DAVIDSON BAY PROPOSED MASTER PLAN AMENDMENT

Proposed Hopper Development Master Plan Amendment for Building Envelopes A + B + C [JAN. 2019]

Proposed Hopper Development Master Plan Amendment for Building Envelopes A + B + C [MARCH 2020]

DAVIDSON BAY MASTER PLAN AMENDMENT

Revision Note:

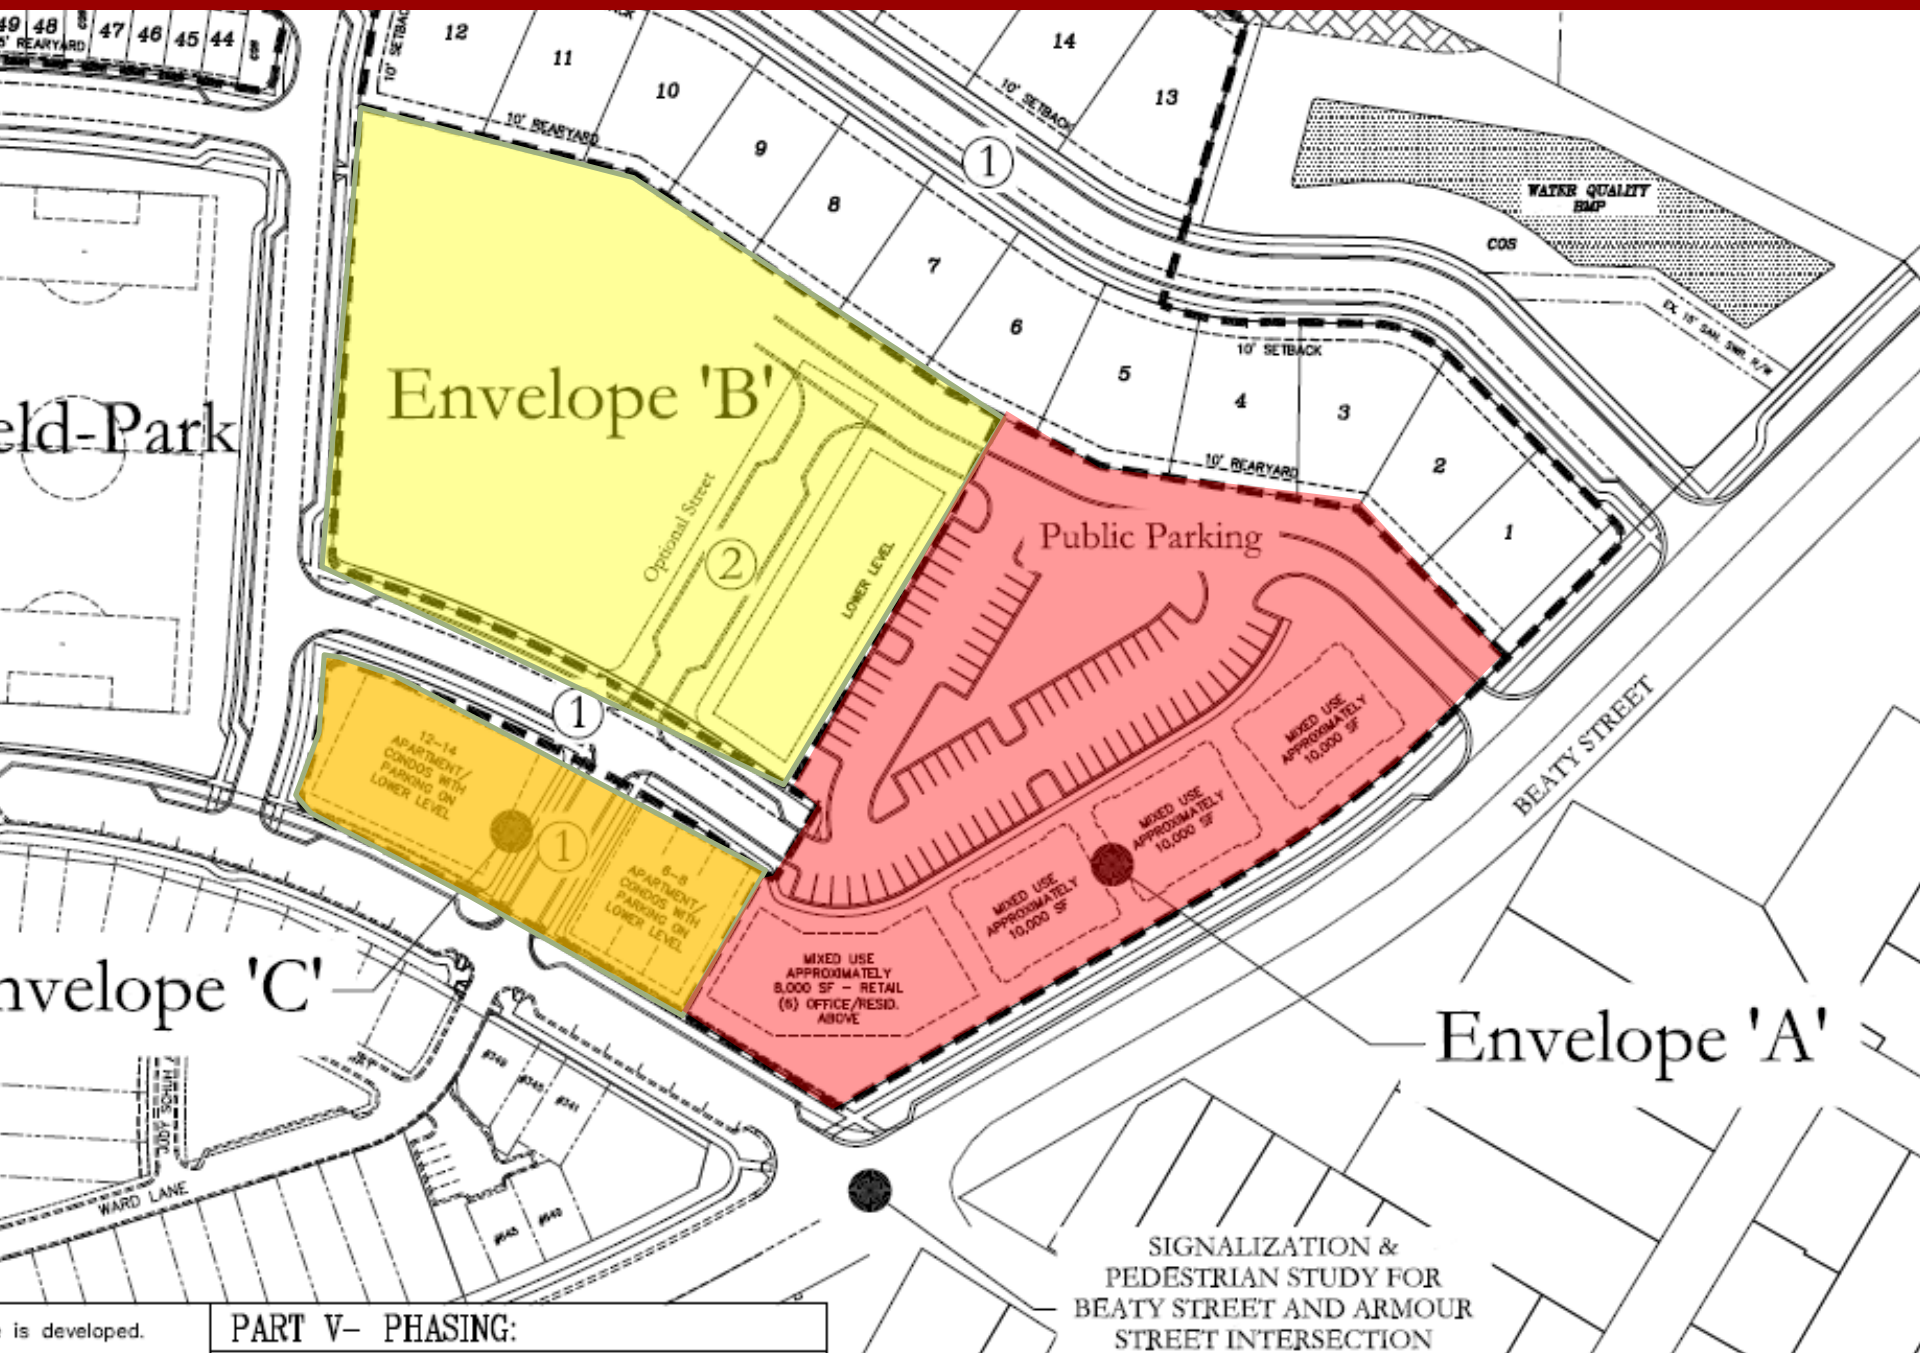
8-06-10 The Existing Affordable revised to reflect the 6 afford

4-15-10 This plan is to revise 118. The Existing Affordable revised to reflect the afforda

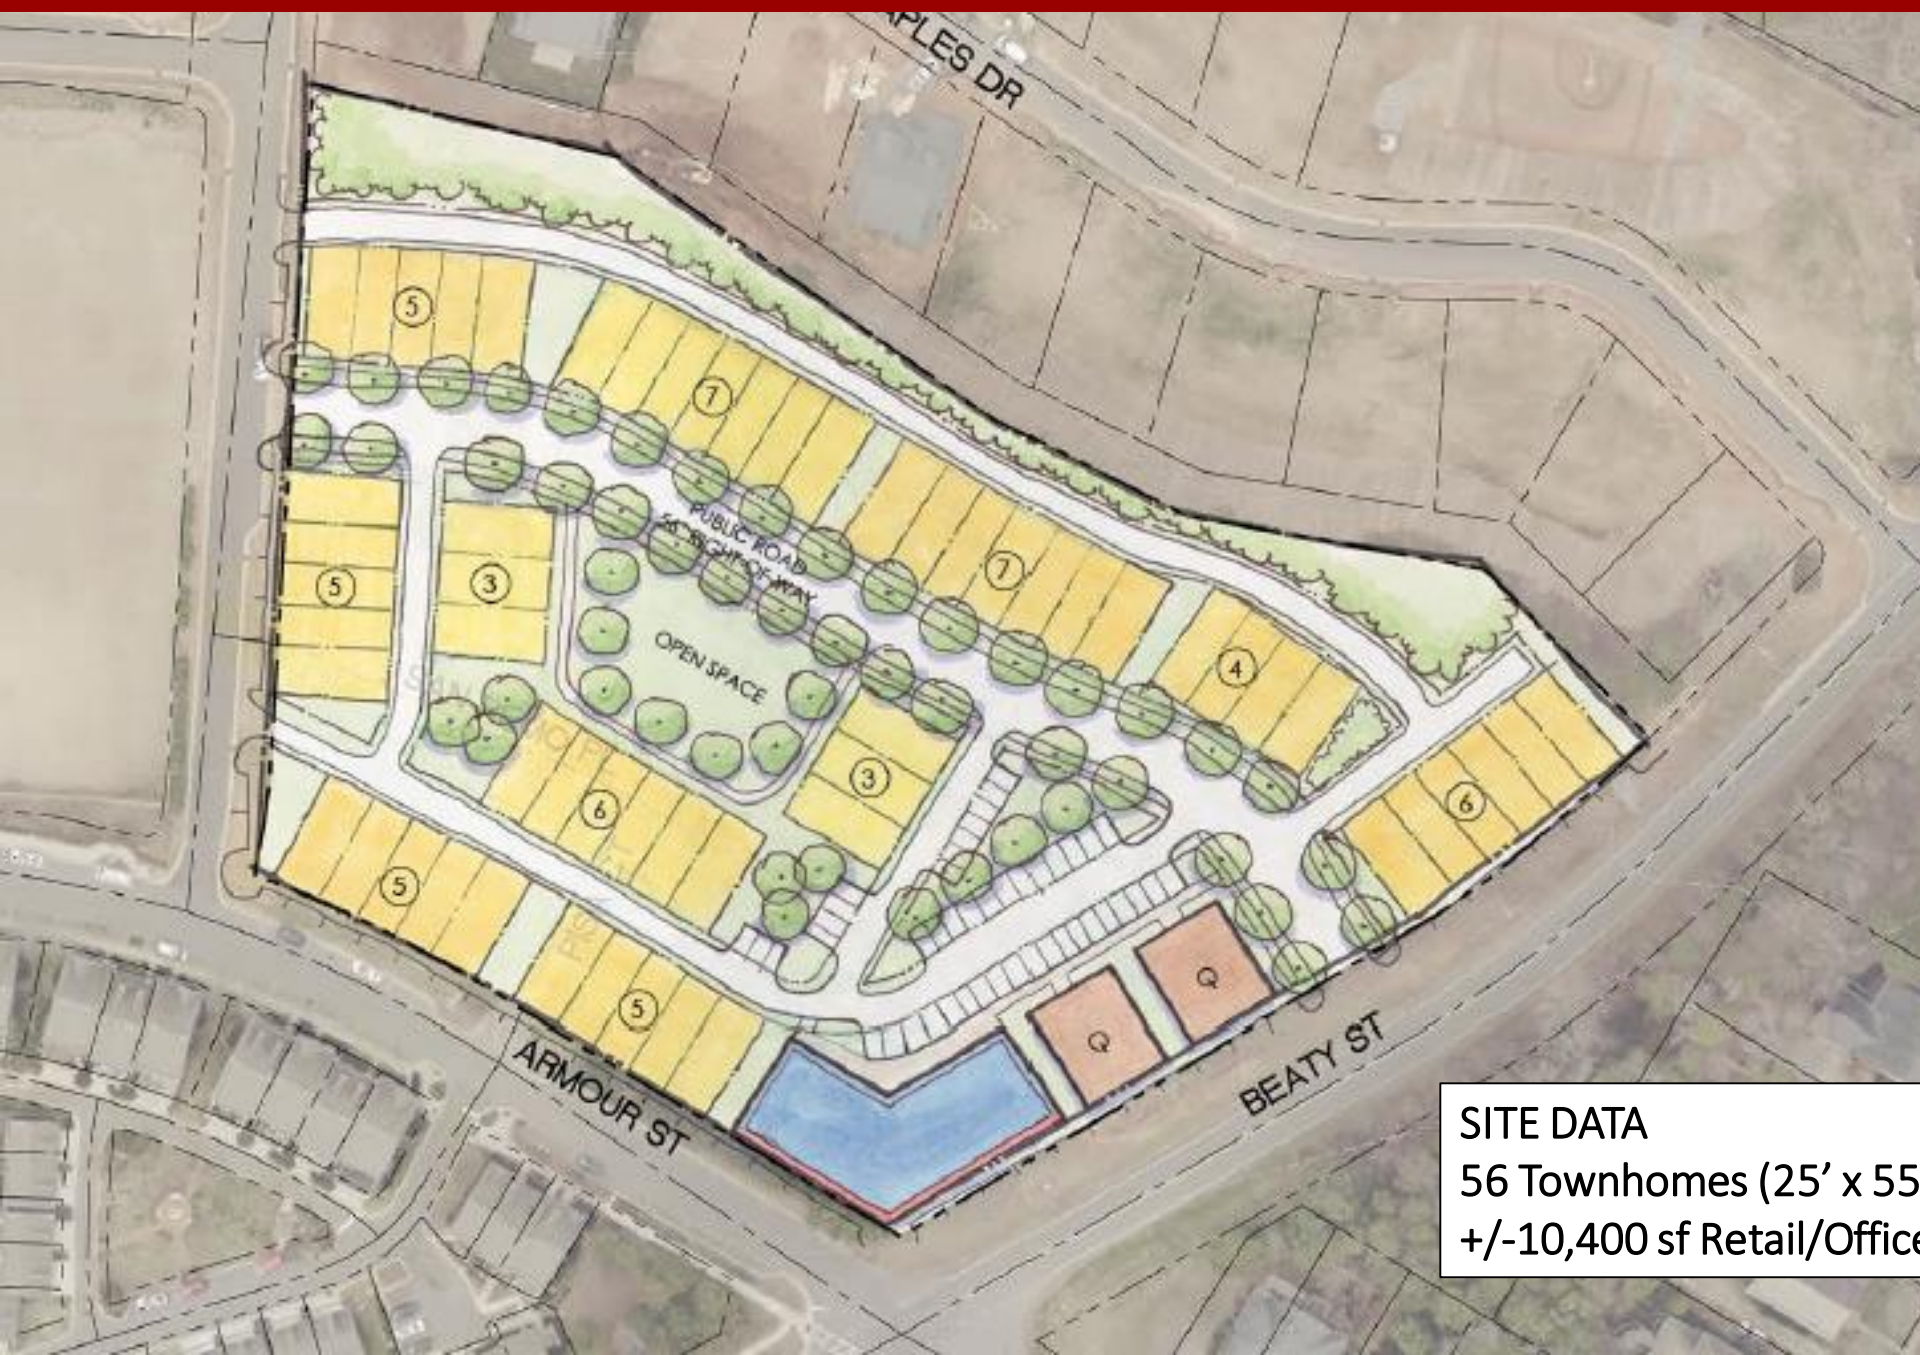
SITE DATA
56 Townhomes (25' x 55')
+/-10,400 sf Retail/Office

2007	2010	Revised Proposed
+/-51,200 sf	+/-38,000 sf	+/-20,400 sf
69-81 du	84-108 du	56 du + 8 quad units

2007	2010	Proposed
280	288	245
